# Staff Report

**Report To:** Special Meeting of Council  
**Meeting Date:** April 2, 2026  
**Report Number:** CFS.26.022  
**Title:** Value Engineering Exercise Review – Mill Street Pumping Station  
**Prepared by:** Monica Quinlan, Director of Corporate & Financial Services;  
Adam Smith, CAO

The purpose of this report is to present the findings of the Value Engineering (VE) exercise approved through [Staff Report CFS.26.009](#) and to outline a recommended path forward for the Mill Street Sewage Pumping Station (SPS) component of the Housing Enabling Water Systems (HEWS) project.

### INTRODUCE CAISSON SUBMERSIBLE PUMP FOR ADDITIONAL CAPACITY

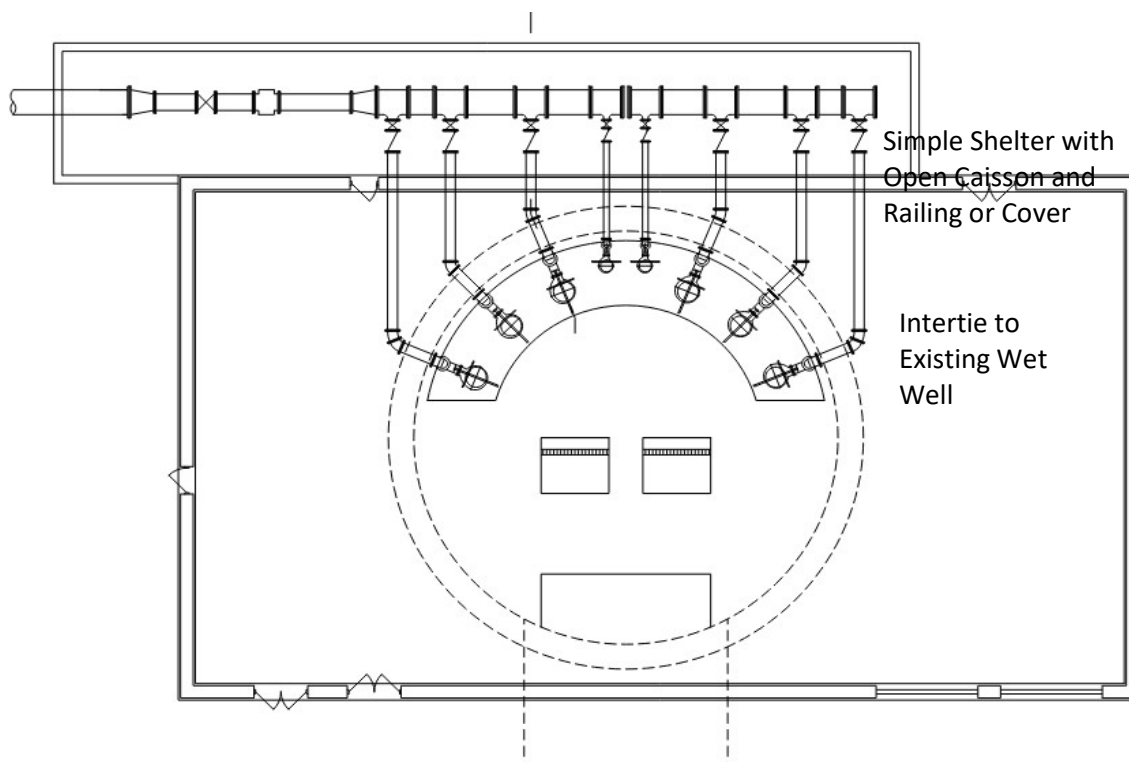
Provide a new caisson wet well with an operating volume of 300 m<sup>3</sup> adjacent to Mill Street PS. The Caisson will have an internal diameter of 10 m. Assume a 1-meter wall thickness with a shotcrete lining. Total Diameter 12.0 m The caisson will be set at a level to be able to receive flow from the newly installed inlet sewer. The floor level will be 169 m. Within the casing will be two 135 l/s 150 HP submersible pumps. These pumps will be equipped with VFD drives and will provide primary service. The existing Mill Street PS will be maintained, and the caisson will be tied to the existing Mill Street higher wet well floor level by a 500 mm Concrete Pipe. The existing station will provide wet-weather flows.

- Lower capital cost.
- More operational flexibility. (Existing Station used for wet weather flows).
- Redundancy.
- More planning flexibility (Additional Pumps can be added to pace flow needs).

UPGRADE THE ELGIN STREET PS

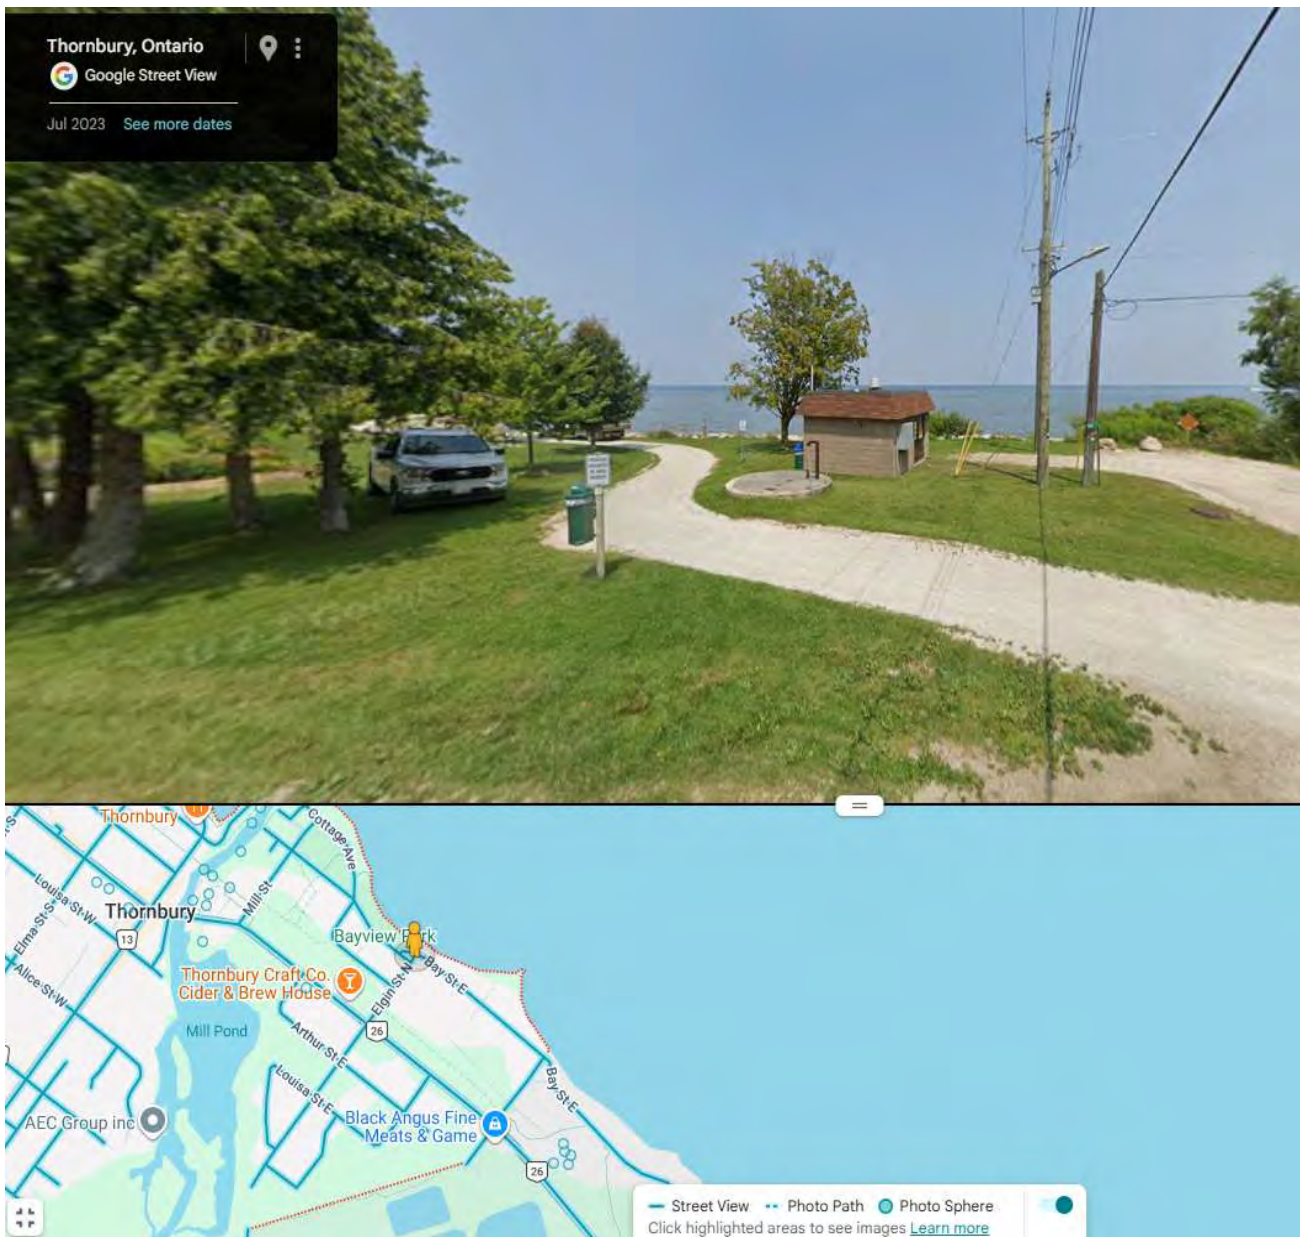
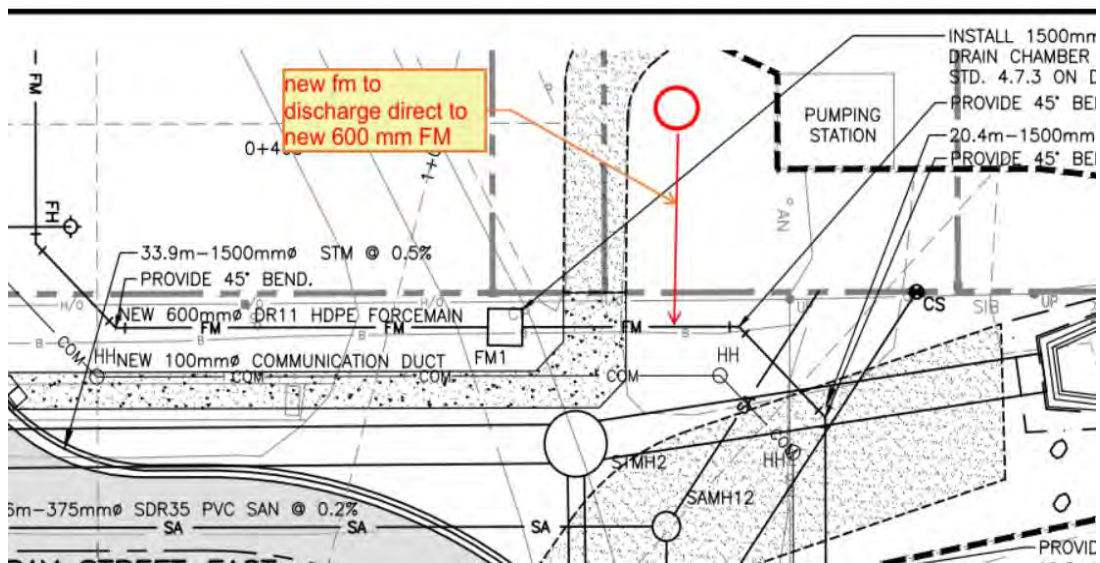
Maintaining the Elgin St. pumping station and upgrading the station to discharge to the new FM currently being installed would remove this sewage flow from the Mill St. catchment; however, the catchment area of this station is limited as well as the design flow of the station. The station has physical capacity to be upgrades for higher flows allowing additional catchment areas to be included in this station, reducing the catchment of the Mill St. SPS. Maintaining the Elgin St. station provides redundancy in the pumping system.

- Install a new 6" force main, tie in to the new FM
- There have been some minor electrical, generator, PLC recent upgrades
- Increase the pumping capacity from approximately 9 L/s at new discharge head in coordination with the operating pressure for the new force main.

**NOTE: THIS SCOPE NEEDS TO TIE INTO RETAINING MILLS STREET PUMP STATION for complete cost saving**

*RE-PLUMB TREATMENT PLANT INLET*

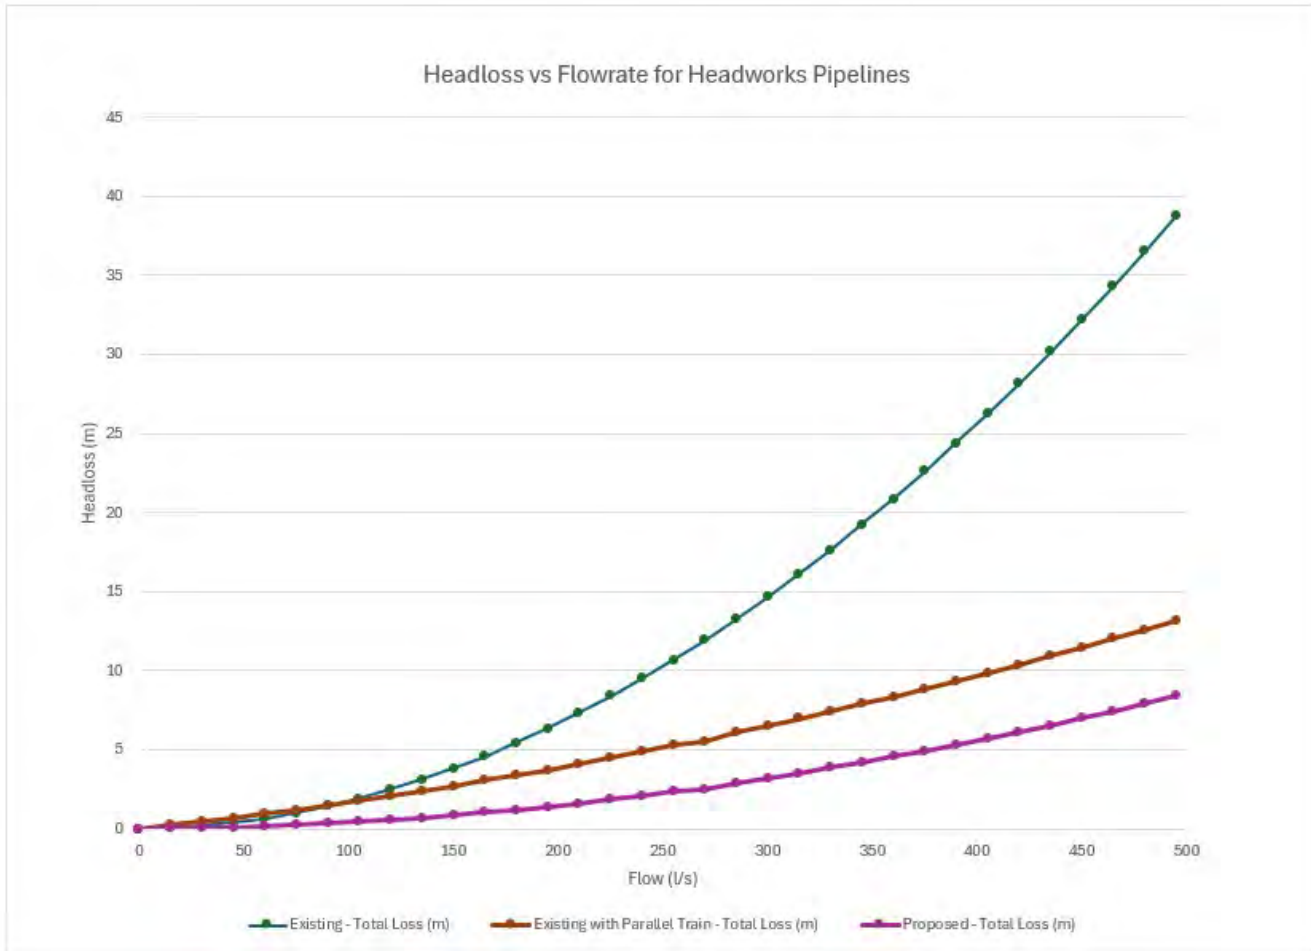
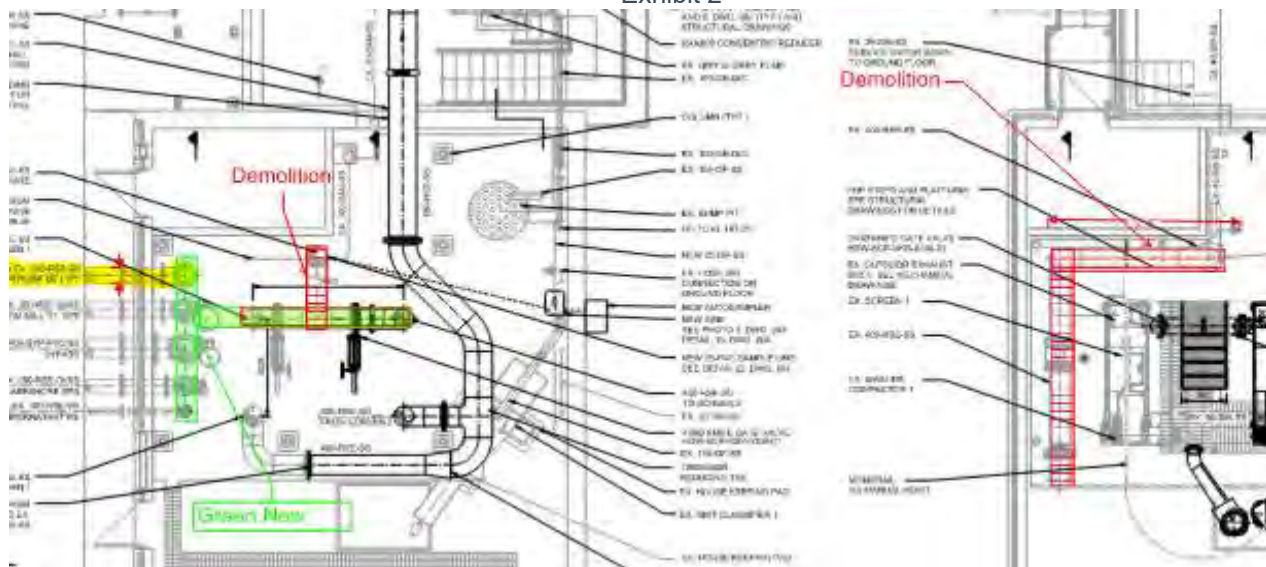
Revise the inlet works to streamline the local losses by eliminating the redundant flow metering and elevated segment for combination air valve. This will allow to reduce the local loss coefficients to  $K=11.7$  to 2.6 for the 400 mm pipe and reduce the lay length from 11.5 m to 7.5 m. This will reduce the total loss from 4.5 m at 450 l/s and 3.0 m at 265 l/s. This reduction in head loss will allow the existing pumps at Hill Street to produce more flow.

**MAXIMIZE EXISTING PUMPING OPERATIONS**

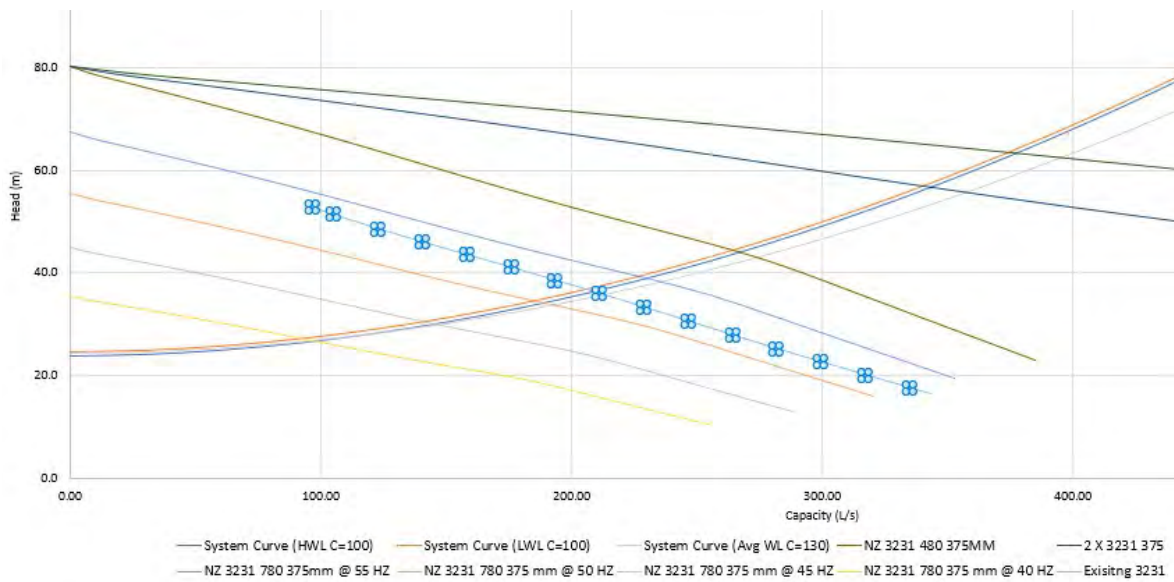
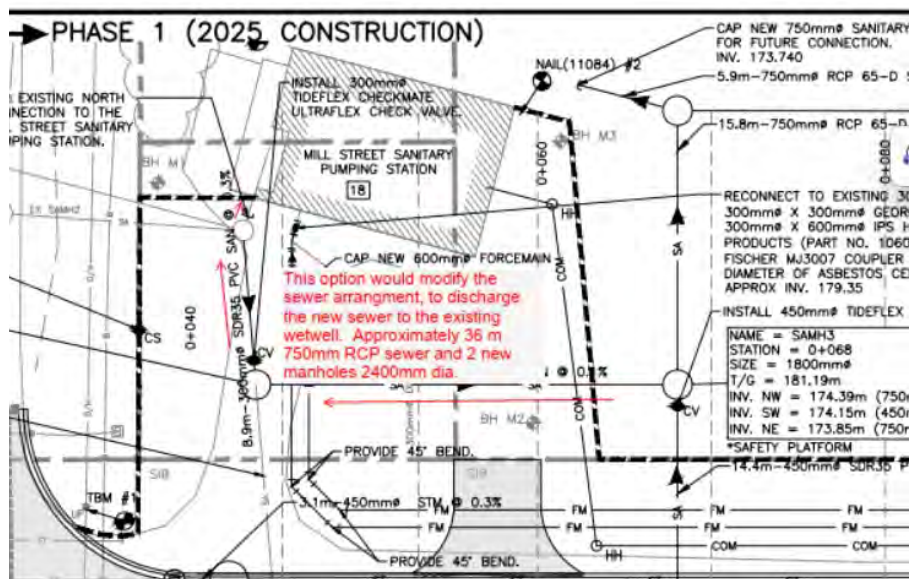
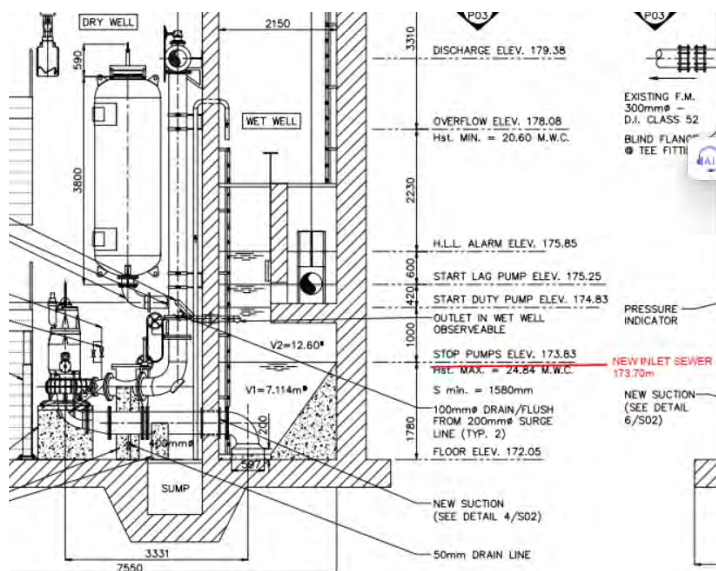
The alternative concept would be to create additional wet well capacity, in combination with the new 600 FM and upgrades 300 mm FM to maximize the output/capacity of the existing pumps. This option would add additional wet well capacity through the use of secant pile construction and deep piping connection to the existing wet well (we are not suggesting to deepen the existing wet well but rather expand the wet well providing additional buffer capacity).

The existing 600 mm inlet sewer enters the pumping station at an invert elevation of 175.065m The available depth within the wet well is limited, currently the active operating volume is approximately 12.6 m3. With the new invert elevation of 173.70m which is lower than the minimum submergence elevation of the existing pumps which would then require surcharging of the inlet sewer to provide operating volume for the pumps. The option would need to be combined with a scenario that utilizes the inlet sewer as the storage/operating volume for the pumping operation.

**The changes to the current arrangement would include modifications to the inlet sewer arrangement (750mm re-configuration), removal or portions of the existing 600mm inlet sewer, breakout of the wet well inlet channel.**

*LINE THE TIMMINS/ LLOYD'S EASEMENT FOR ADDITIONAL CAPACITY AT CRAIGLEITH*

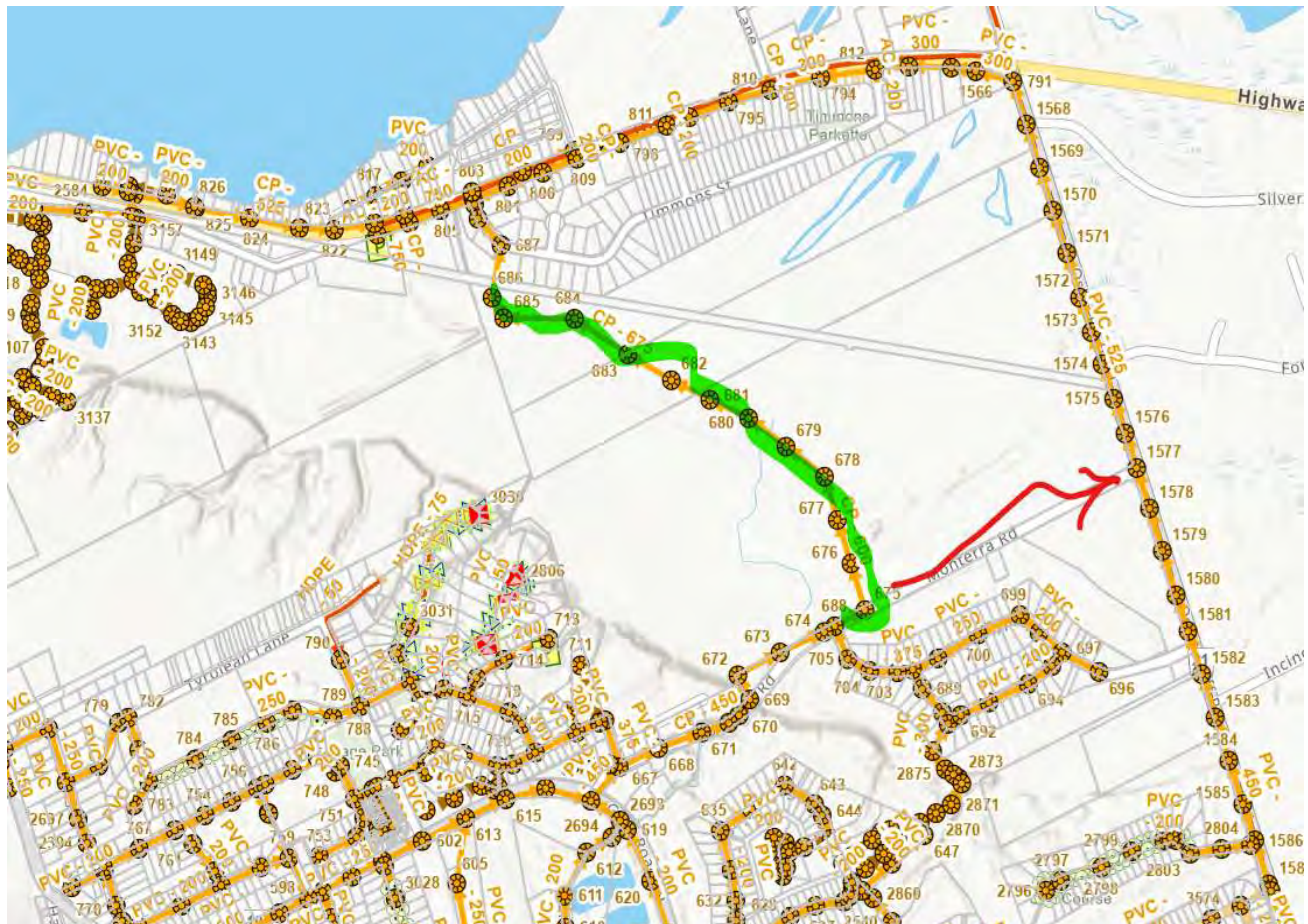
- 1) Excavate and replace the failed sections of pipe through this easement. (Cost unknown)
- 2) Remove sewer and water from this easement and realign to another path to WWTP (would need a PS and forcemain), Cost Unknown - requires new PS and pipe installed.

This section of the sewage collection system has been identified as a source of I&I. Preventing I&I will improve the capacity of the collection system and WWT plant.

REMOVE COVER, SIDES AND ROOF OVER THE DRY WELL

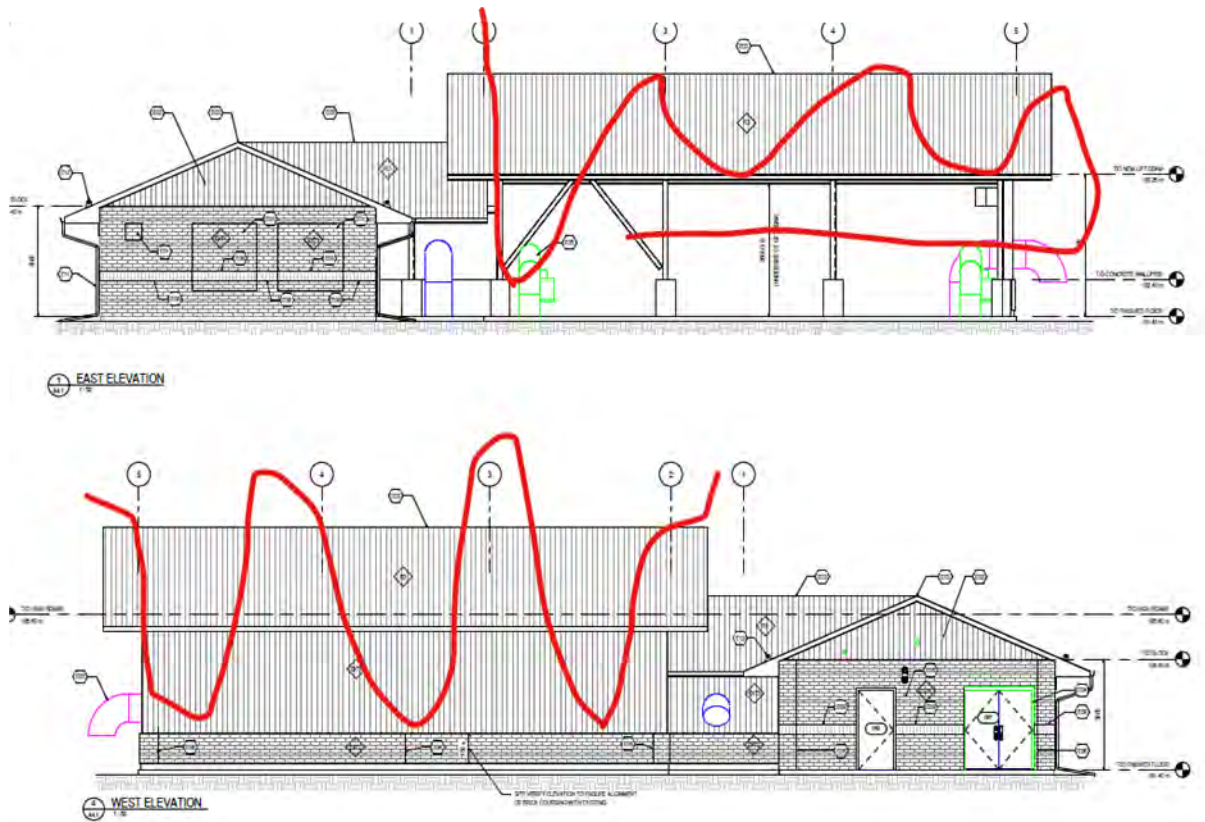
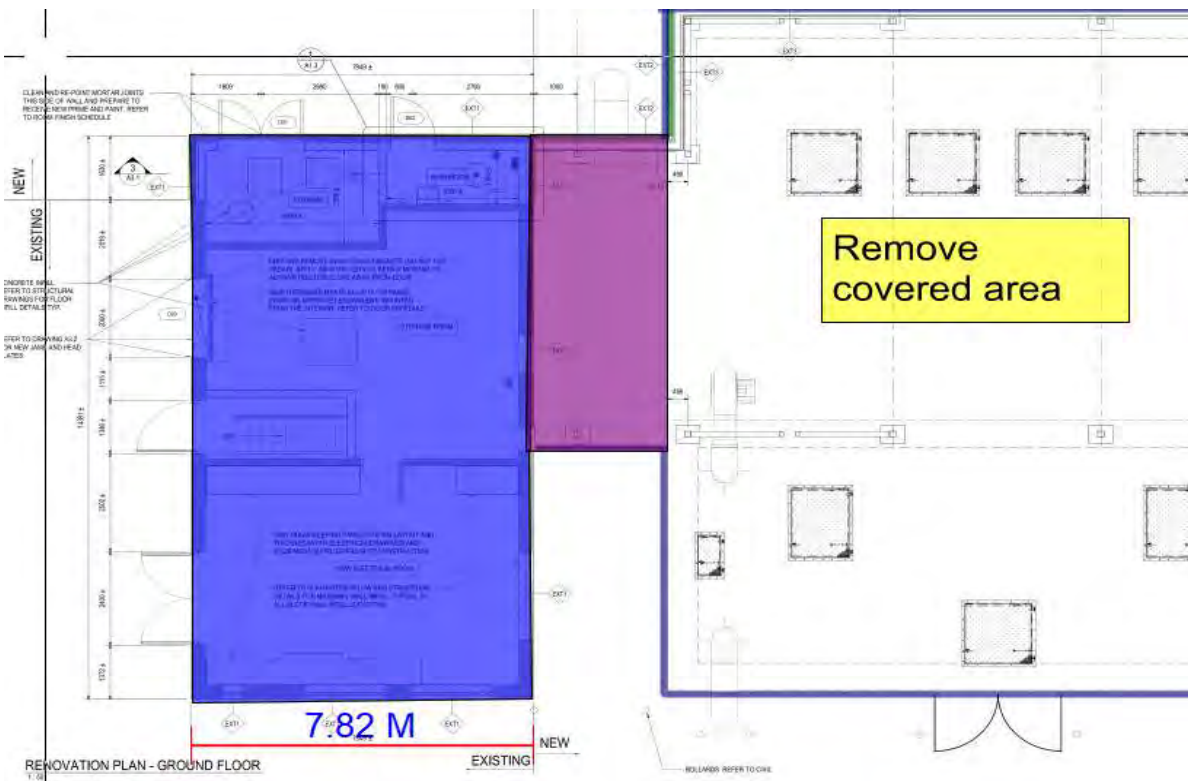
- Modifications to the existing/new inlet sewer to convey the sewage to the new station
- Construction of a new control building to include electrical/mechanical maintenance space as well as the new washroom. This is a building and stair well to access the new dry well/wet well.
- We would also include the demolition of the existing station within this scope.
- New Control Building floor area ~1,800 ft<sup>2</sup>
- New Stair well to access the dry well area (Depth ~12.9 m, 3 landings)
- Add a valve chamber for the drain valves on the forcemains
- Add a metering chamber for the FM flow meter

Description	Unit	Quantity	Unit Cost	Total
Construct Control Building (1,800sf) including a washroom	sum	1	\$940,643.32	\$940,643
1 metering and valve chamber	sum	1	\$450,000.00	\$450,000
Conveyance	sum	1	\$422,500.00	\$422,500
add Deferred maintenance to existing Mills	sum	1	\$899,413.10	\$899,413
+the original concept, potentially modified with the Caisson+submersible pump option.	sum	1	\$4,500,000.00	\$4,500,000
Electrical upgrade	sum	1	\$1,800,000.00	\$1,800,000
Demolition of existing Mills Station	sum	1	\$250,000.00	\$250,000
New Stair well to access the dry well area (Depth ~12.9 m, 3 landings)	sum	1	\$2,700,000.00	\$2,700,000
